Architectural Review Committee Staff Report Meeting Date: March 18, 2024

PETITIONER: Cityscape Residential

PETITION: Broadacre Apartments Product Approval

Exhibit A (Site Plan)

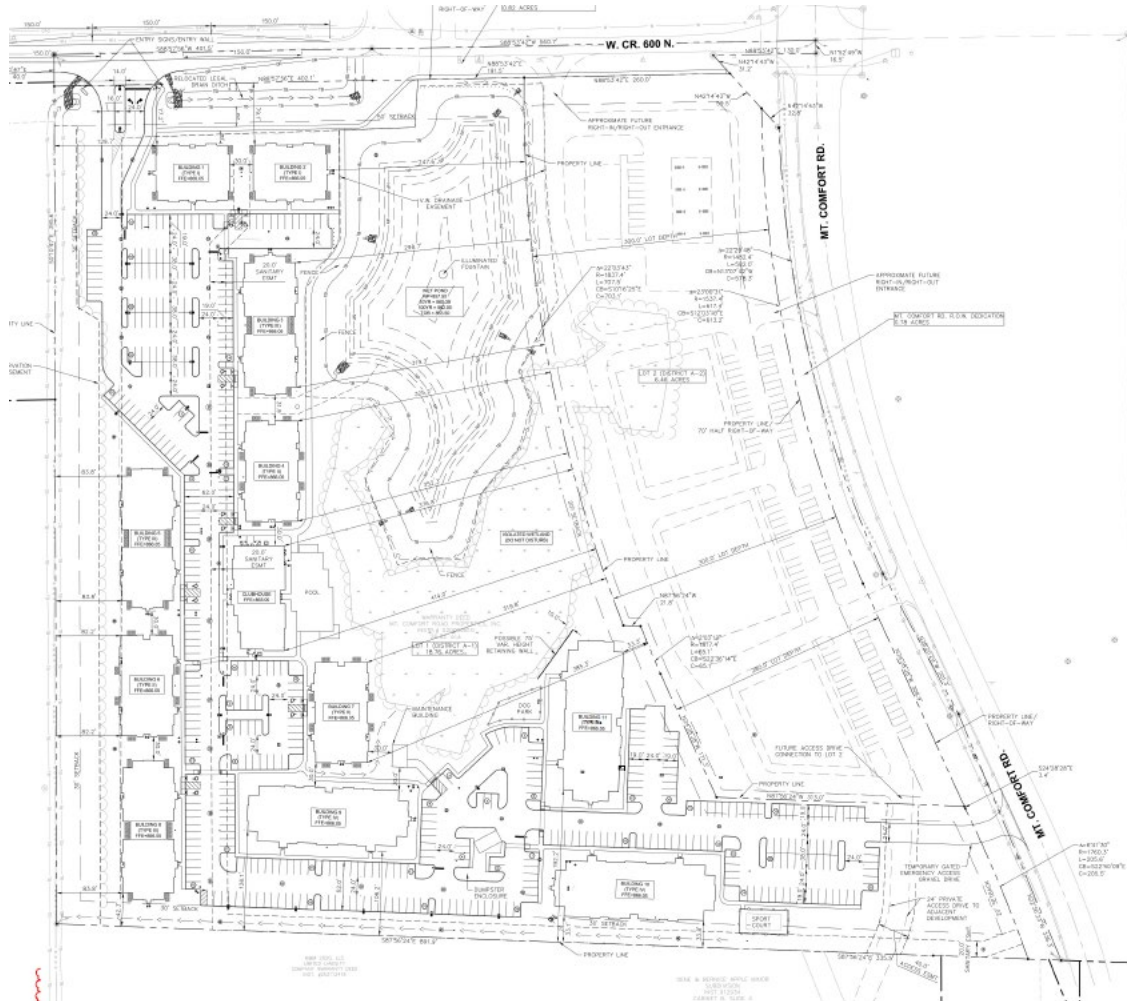
- Please confirm the side elevation of Building #1 facing the internal street does not have a wall mounted meter bank.
- Four-Story Buildings
 - The PUD includes some requirements for additional brick on elevations (of Buildings 10 & 11) facing 600W. The site plan has been tweaked some since the rezoning due to various site challenges. This was contemplated in the PUD, which gives the ARC some ability to interpret where this brick should be placed. We will discuss at the meeting.
